FEC based AM unlock (Comment #??)

AM unlock

Implemented Solution for 802.3bs in Draft 2.1

Ethernet signal transported via OTN

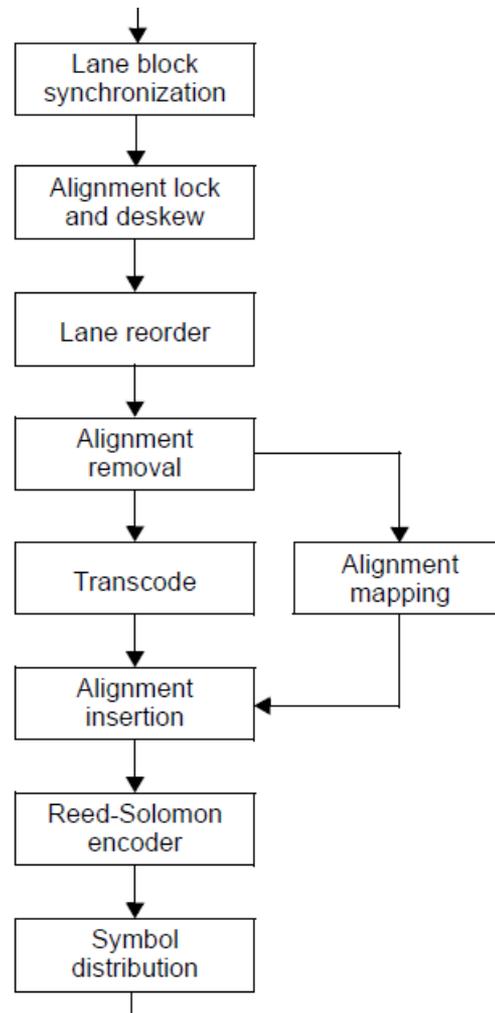
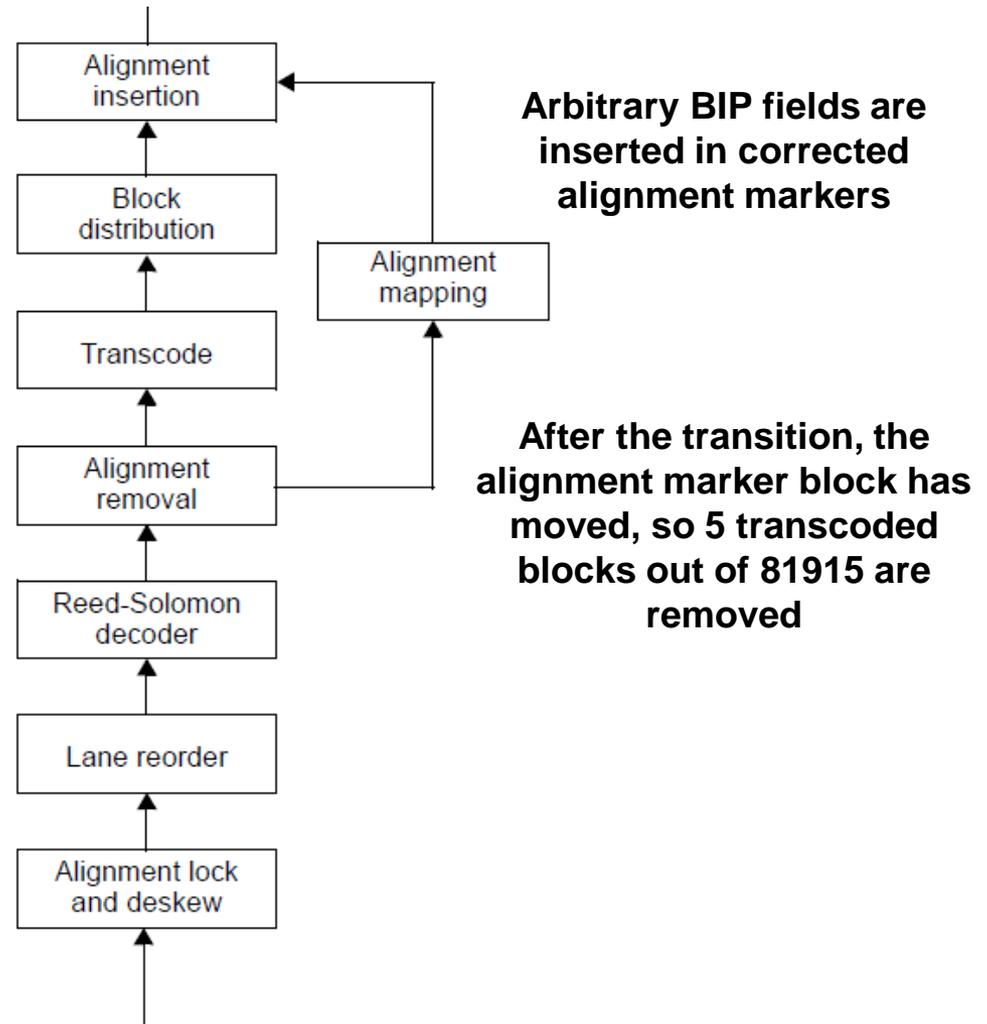
When fault is repaired, signal here changes from Ethernet containing LF generated at ingress node to Ethernet from remote client

Position of the AMs in the two signals is different

Reed-Solomon encoder may continue to send valid codewords throughout transition

PCS sees sync header violations from transcoder, an invalid BIP ratio of 0.996 and loses some frames, but the link stays up

Transcoder “decodes” the AM block

Reed-Solomon decoder see continuous stream of valid codewords

Alignment lock is only lost for 3 consecutive uncorrectable codewords

Figure 119-12—Alignment marker lock state diagram

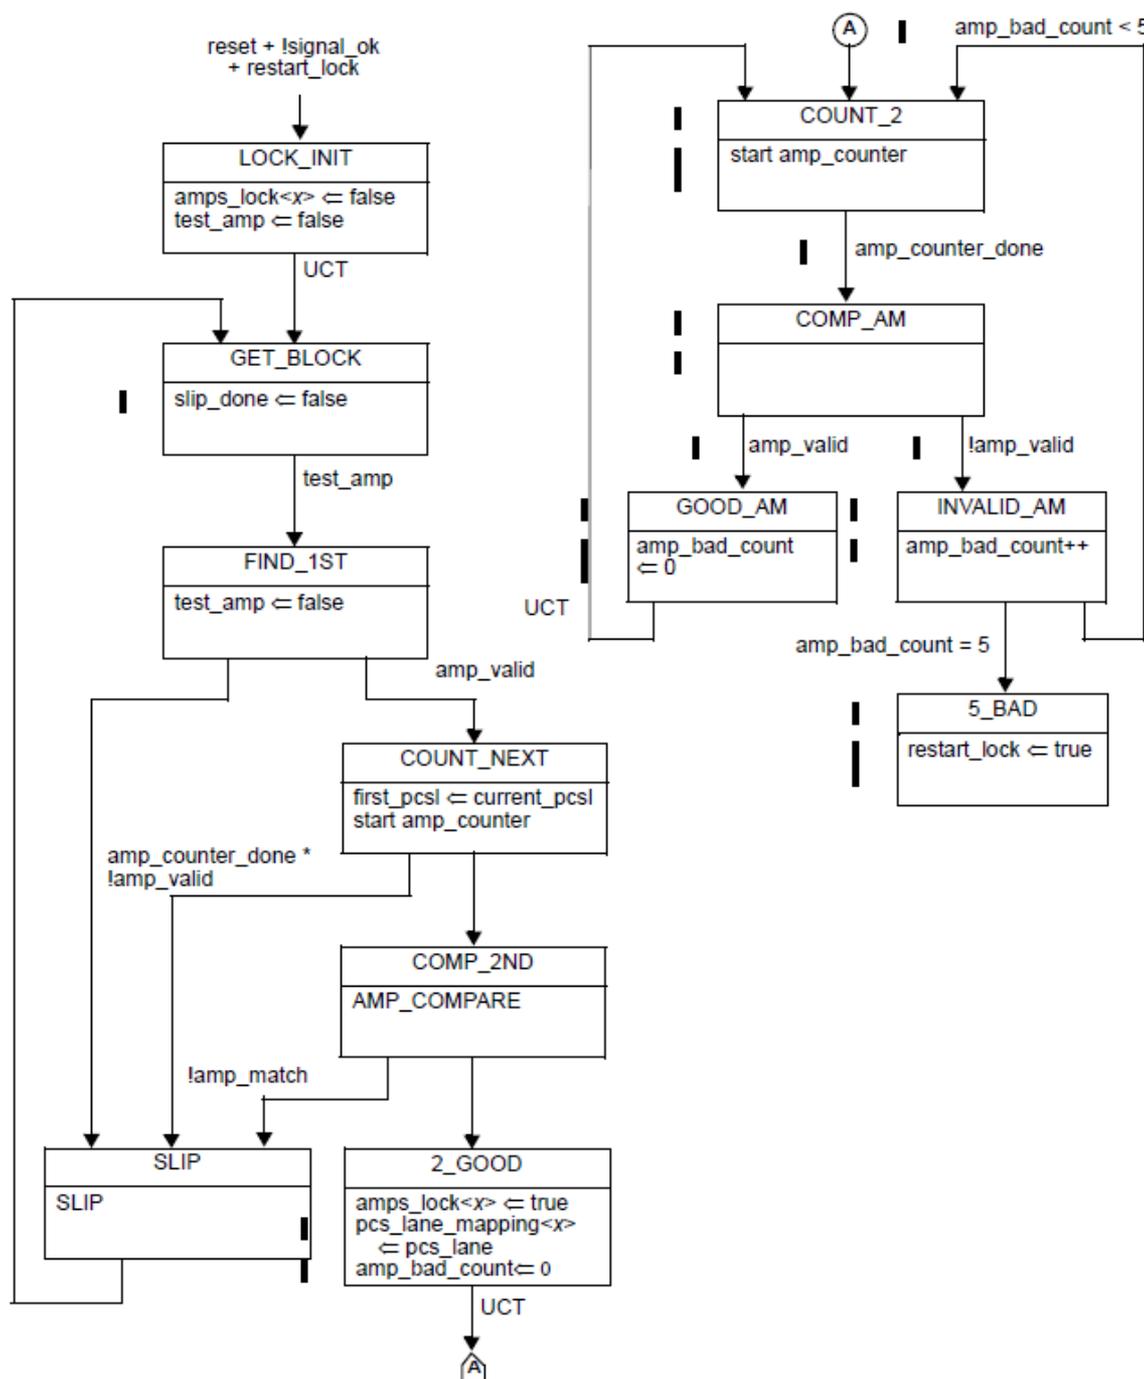
Boolean variable that is set by the PCS alignment process to reset the synchronization process on all PCS lanes. It is set to true after 3 consecutive uncorrected codewords are received (3_BAD state) or when 5 Alignment Markers in a row fail to match (5_BAD state) and set to false upon entry into the LOSS_OF_ALIGNMENT state.

Counts the number of consecutive alignment markers that don't match the expected values for a given PCS lane.
